CONTEMPLATED CHANGE ORDER

PROJ.: Meridian Community
Building Rebuild
PROJ. No.: 1841
DATE: Aug. 29, 2019
C.C.O. No. 014

14.1 TITLE

Misc. Electrical at Fireplace Surround

1. Reference Drawing E3:

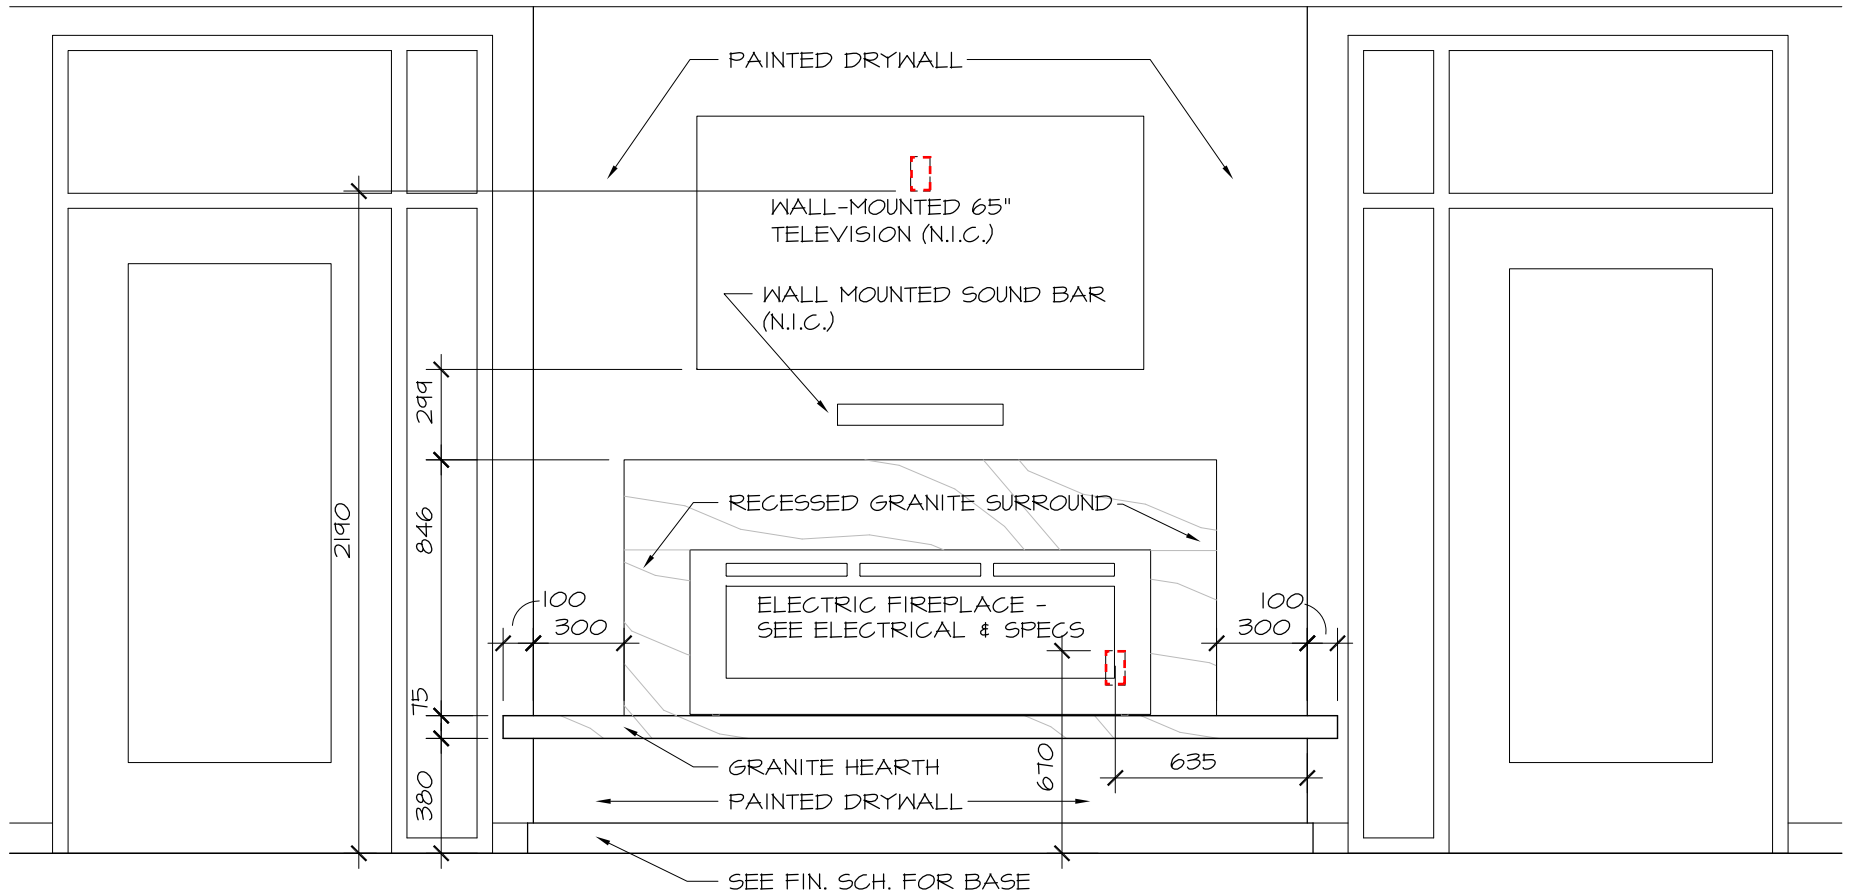
- .1 Delete fire alarm pull stations at fire place near grid lines O/26, typical of two (2)
- .2 Revise duplex receptacle circuit PB6-13 to quad receptacles at fireplace and install in accordance with architectural elevations.

FIREPLACE — FRONT ELEVATION

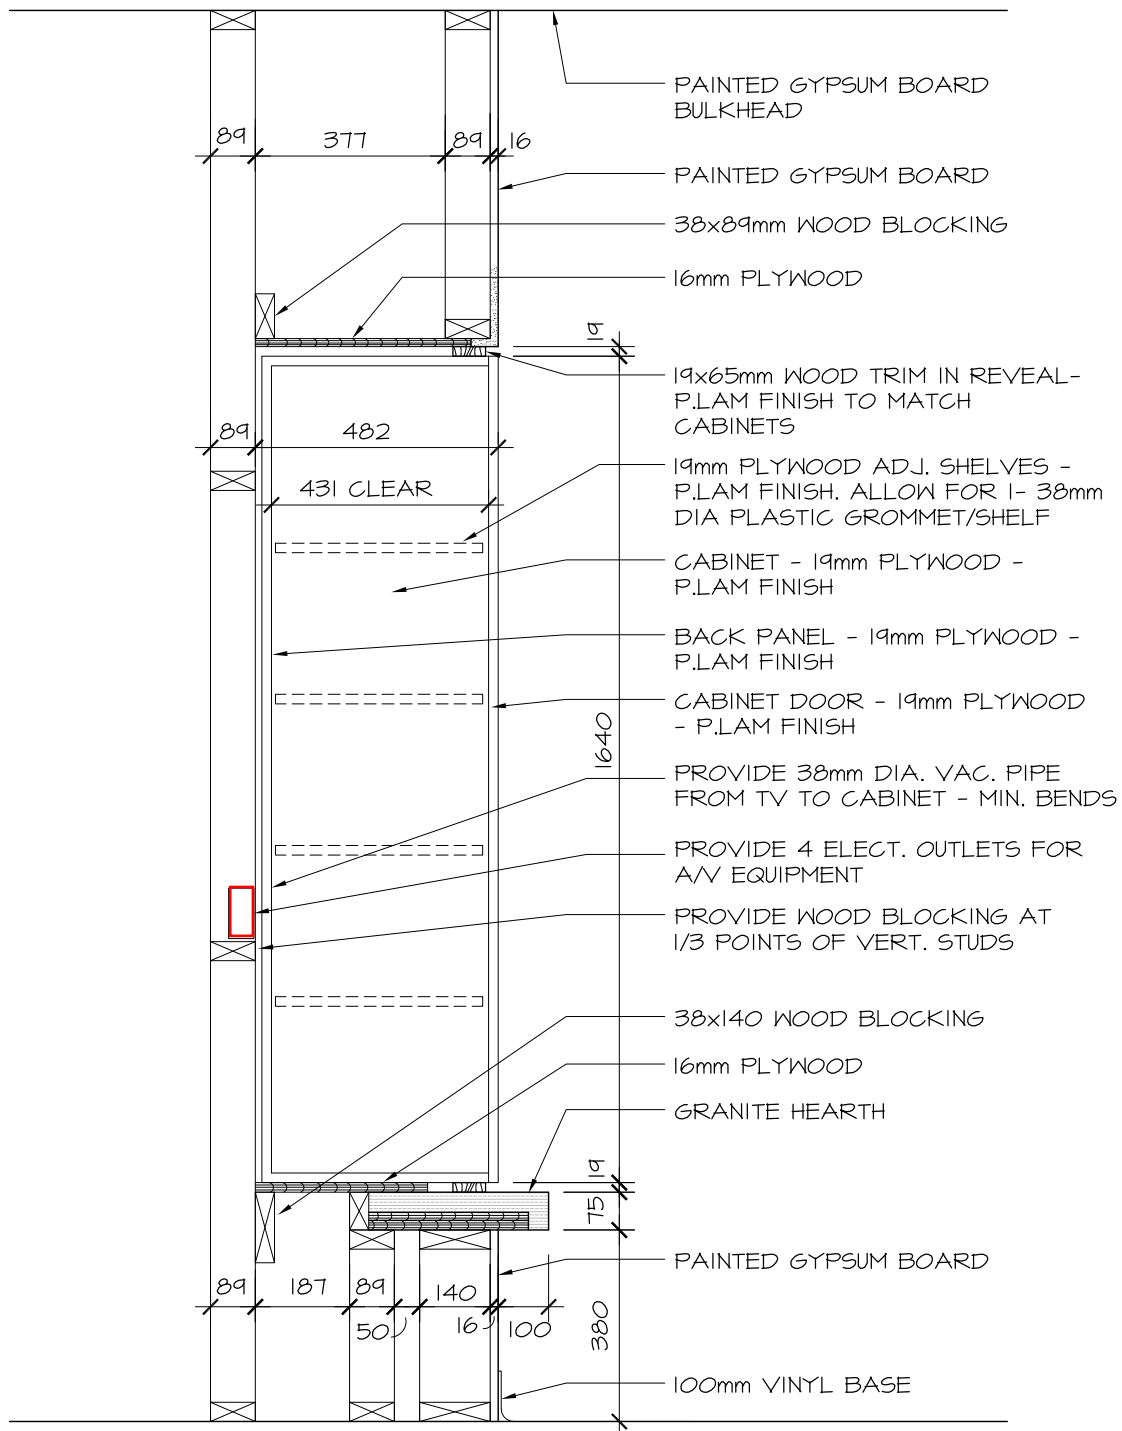
- .1 Refer to the attached Electrical Contemplated Change Order CCO-E-3 by Goodkey Weedmark & Associates Limited for the electrical requirements of this CCO.
- .2 Refer to attached Architectural sketches for the location of the outlets in the fireplace surround.
